**KERI DONALDSON**

**OBJECT**

Submission ID: 217087

*I strongly object to this proposal. It is not in the right location. Detailed submission attached.*

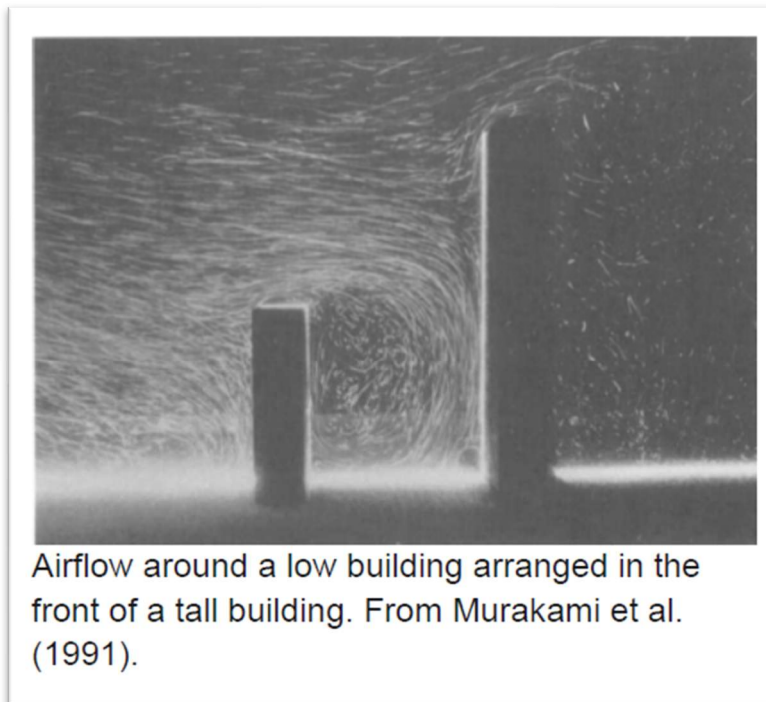
Has it been addressed what effect the WWTP will have on the wind flow as according to the research below "turbulent flow remains one of the unresolved problems of classic physics" (12).

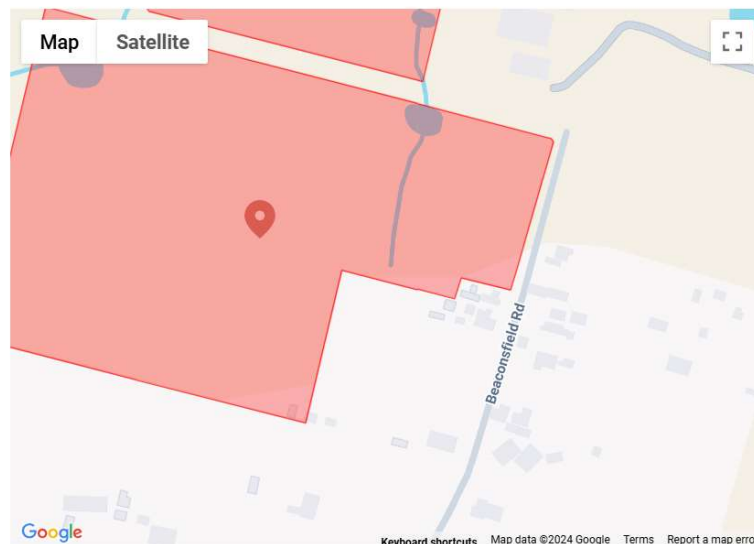
GHD state repeatedly that the site is not in a bush fire zone. (8)  
Yet NSW Rural Fire Service list the site as in a bush fire zone. (9)  
If GHD are reporting with out-of-date information it is not in the public interest.
